21-081MPR – OHIOHEALTH – EXTERIOR MODIFICATIONS

A request for review and approval for exterior modifications to an existing building located at 250 W. Bridge Street in the Bridge Street District.

Original brick on top; stained brick on bottom. "A" has one coat of stain; "A Plus" has two coats of stain.

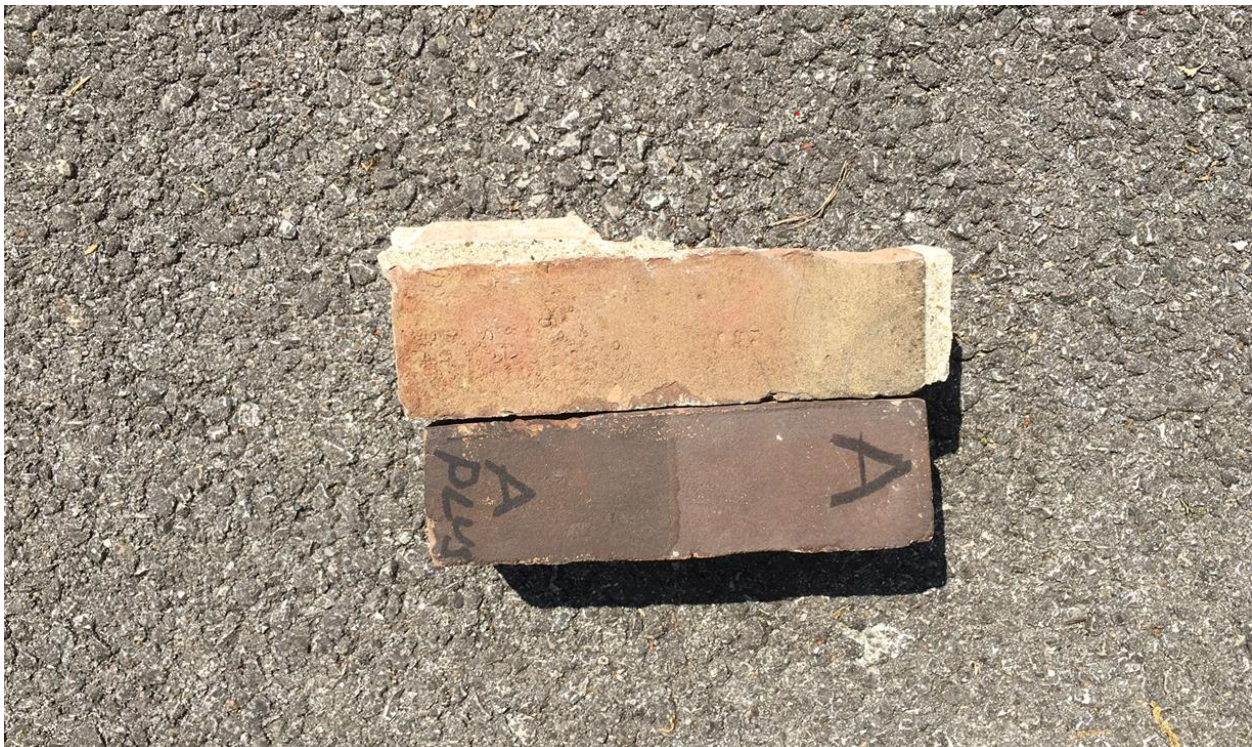
Two color samples were submitted: one with one coat of stain and one with two coats of stain. Given the existing color of the brick, Staff recommends that the applicant apply two coats of stain to ensure a more intentional change of color and adequate contrasts on the building.

Staff has not had experience with this product, and therefore, recommends a condition to ensure that the building maintains the intended appearance.

- 1) If, at any time in the future, as determined by staff, the stained bricks’ appearance becomes unacceptable, the City of Dublin has the right to require the owner to make immediate (within 90 days) repairs or replacements, including re-staining or, up to and including, replacement or covering the stained brick material. Solutions shall be reviewed by staff and the required reviewing body and shall only be installed after a formal approval.
- 2) Staff recommends that the sample labeled “A Plus” be used (with two coats of stain) to enhance the contrast with the existing brick.
